RCA MANUFACTURING CO., INC.

SUBJECT: LOEW'S THEATRE INSTALLATIONS

NUMBER 2012-1.2

Equipment to be Installed in Loew Theatres

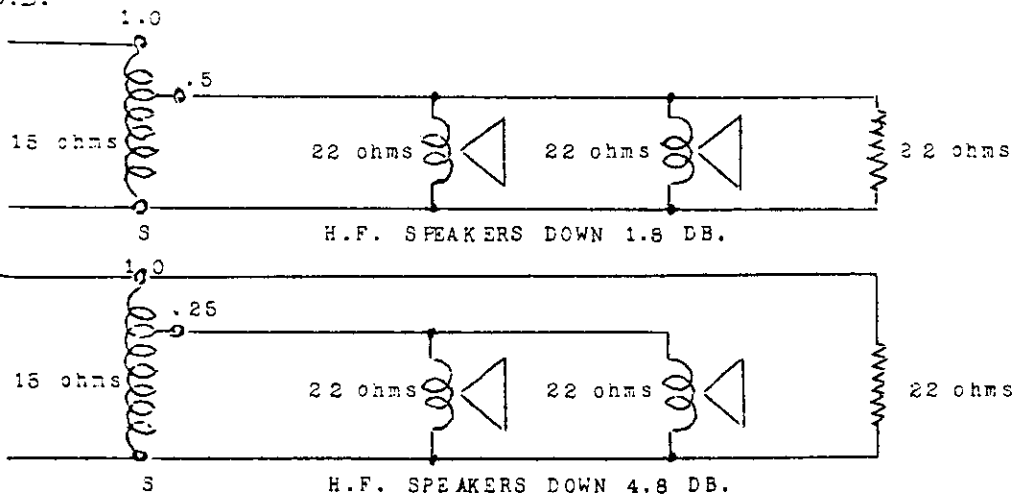
A 22 ohm resistor has been added to the coupling transformer for the high frequency speakers and the designation of the transformer changed to MI-1491. In order to obtain the proper acoustic balance, in most theatres it will ordinarily be sufficient to pad the H.F. speakers for a 3 D.B. loss as shown below

The two diagrams below show additional connections for loss values above and below 3 D.B.

PO-01 AMPLIFIER (MI-4236 & 2 MI-4256's)

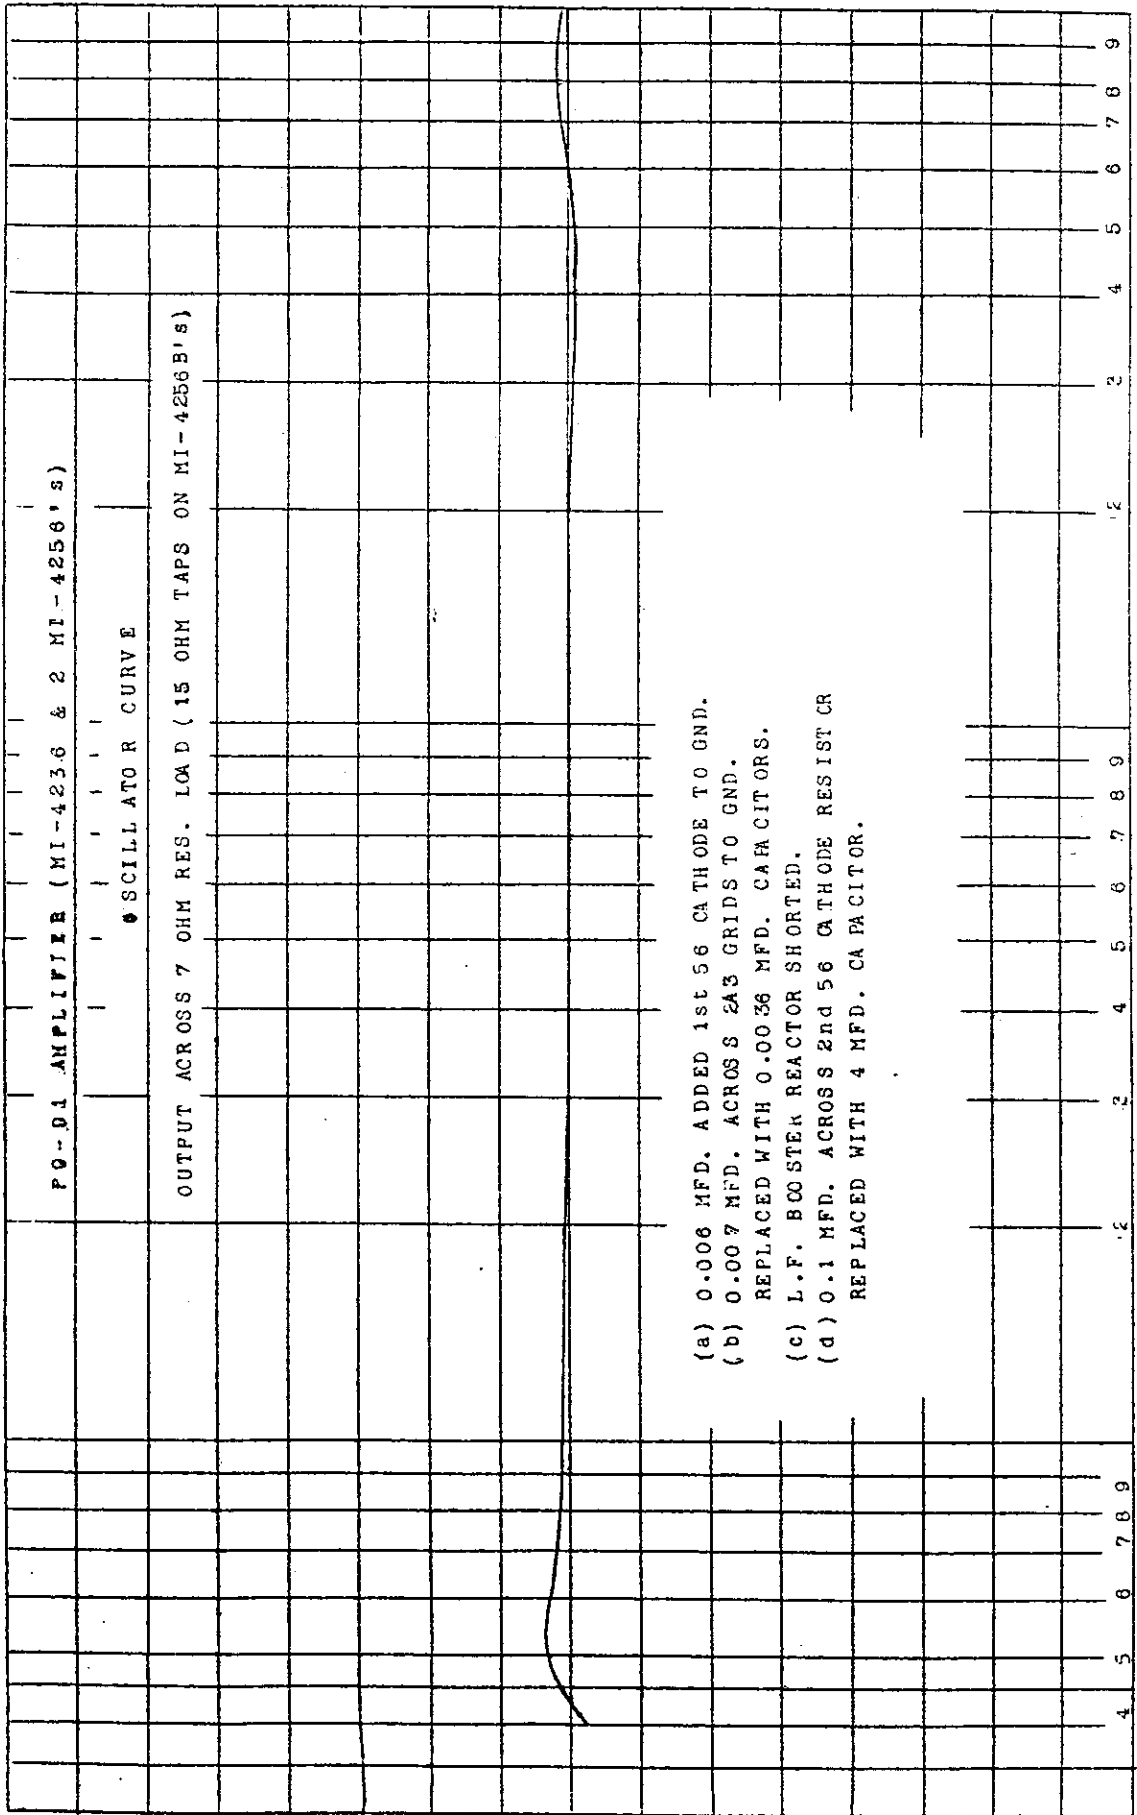
The frequency response characteristic for the MI-4236 and two MI-4256-B, as shipped, will be as shown in the attached sketch. Changes made in the amplifiers to produce this curve are as follows: Refer to Drawing No. TX-260139, part of 2012-1.1.

- (a) Added 0.006 mfd. across cathode resistor R-22 in second stage (RCA-56)
- (b) Low frequency booster shorted.
- (c) Replaced capacitor C-14 (0.1 mfd.) with 4.0 mfd. across cathode resistor R-21 in third stage (RCA-56).
- (d) Replaced capacitors C-47 and C-48 (0.007 mfd.) with 0.0036 mfd.

- (a) 0.006 MFD. ADDED 1st 56 CATHODE TO GND.
- (b) 0.007 MFD. ACROSS 2A3 GRIDS TO GND.
REPLACED WITH 0.0036 MFD. CAPACITORS.
- (c) L.F. BOOSTER REACTOR SHORTED.
- (d) 0.1 MFD. ACROSS 2nd 56 CATHODE RESISTOR
REPLACED WITH 4 MFD. CAPACITOR.
